<h1 style="margin: 0;">TECHNICAL BULLETIN</h1> <h2 style="margin: 0;">No. 0110</h2>	<h1 style="margin: 0;">Operator's Panel Plate</h1>
---	--

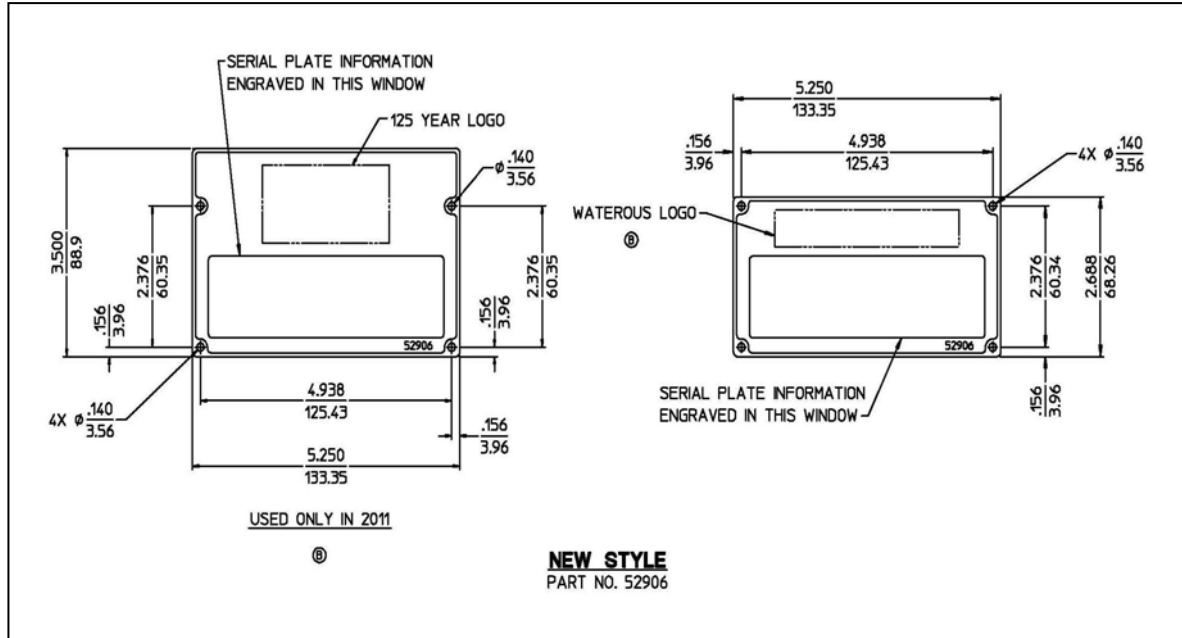
- Plate Dimensions:** The height of the panel plate has increased by .812 inches to accommodate the new Waterous 125th anniversary logo. All other dimensions of the panel plate remain the same including the attachment points (see figure below).
